SECTION "A-A"

J	182170	DESIGNED & DRAWN	DATE	SCALE	REV	BY	CHK'D
VY13F6 ASSEMBLY DWG.							
SHEET		VY13F6		J PR

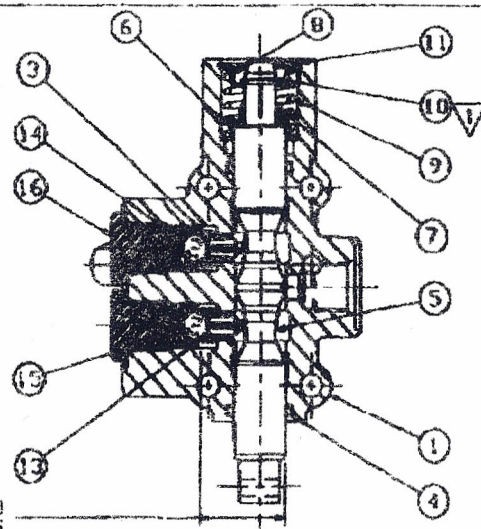
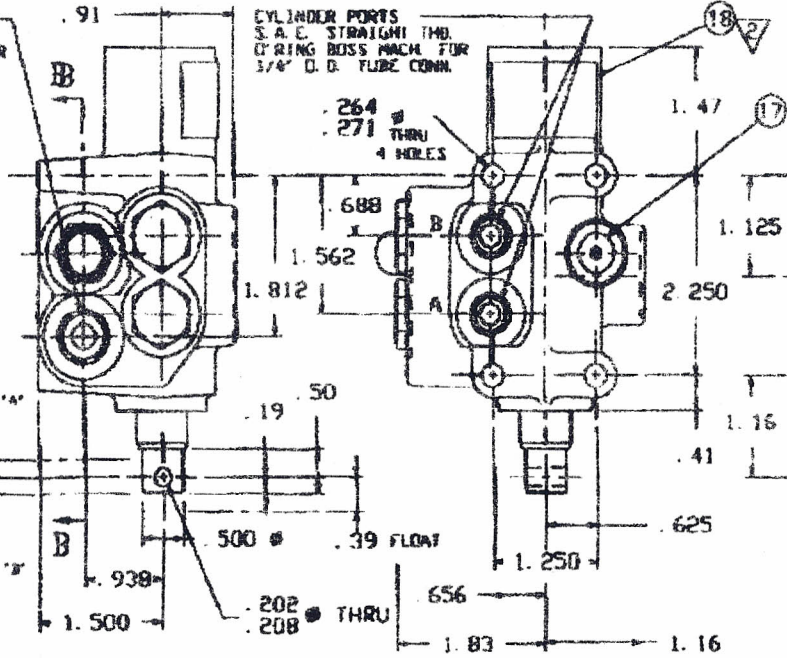
IF deck is Leaking down grind approx .005 OFF OF ITEM (13) ON END THAT CONTACTS BALL.

IF spool assembly is removed. MAKE SURE you remove the check assemblies first
